SPECIAL MEETING OF COUNCIL

Notice is hereby given of a
Special Meeting of Council to be held in
Public Hall, 211 Main Street, Bacchus Marsh on
Wednesday 17 September 2014,
commencing at 5:00 p.m.

The purpose of this report is to consider the Panel report and to determine whether to accept the Panel recommended changes to the amendment as per S27(1) of the Planning and Environment Act 1987 (P & E Act 1987), or abandon the amendment as per S28 of the P & E Act 1987. In addition, the report addresses issues raised during the life of the amendment.

Figure 1: Ascot Avenue/Rosehill Drive Intersection (Nearmap.com)

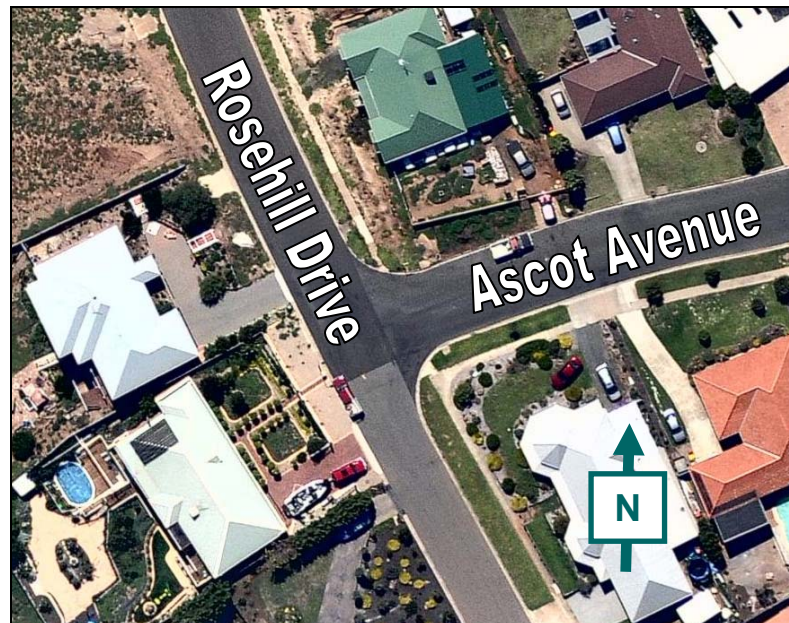
The Planning Panel's first traffic and transport recommendation is to undertake an assessment of the available sight distance at the Rosehill Drive/Ascot Avenue intersection. The results of this assessment are detailed in the following section.

The intersection of Rosehill Drive and Ascot Avenue is shown in Figure 1 below.

For the proposed intersection the sight distance of concern is Safe Intersection Sight Distance (SISD) which assesses a vehicle's ability to stop in the event a vehicle turning out of the minor road (Ascot Avenue) stalling across the traffic lanes.

Figure 2: AM Peak Traffic Volumes - 2011

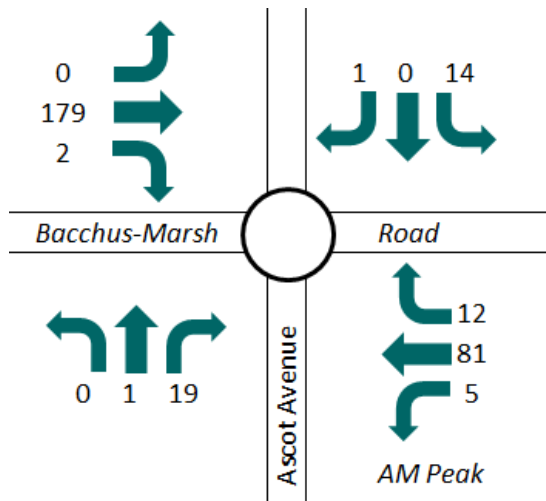
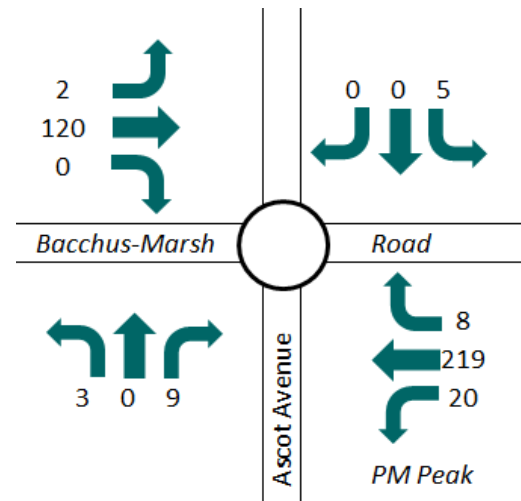
The Panel expressed concern about this trigger, stipulating that the 800 lot figure may be too high and more detailed investigations should be undertaken. In particular, the capacity of the intersections at Ascot Avenue and Rosehill Drive and Ascot Avenue and Bacchus Marsh Road to accommodate additional vehicles was raised as a concern.

GTA have previously undertaken traffic counts at the roundabout on 29th March 2011 between the hours of 7:30am-9:30am and 2:30pm-6:00pm. The results of these surveys are detailed in their report dated 3rd May 2013 (GTA ref: JM15170).

The observed volumes during the AM and PM peak hour periods are shown in Figures 2 and 3 below.

We note that the GTA volumes are based on 2011 volumes. Accordingly, the through volumes on Bacchus Marsh Road have been factored up by 2% per annum for 13 years. This is to allow additional growth on Bacchus-Marsh Road since 2011 as well as a ten year design-life to the year 2024.
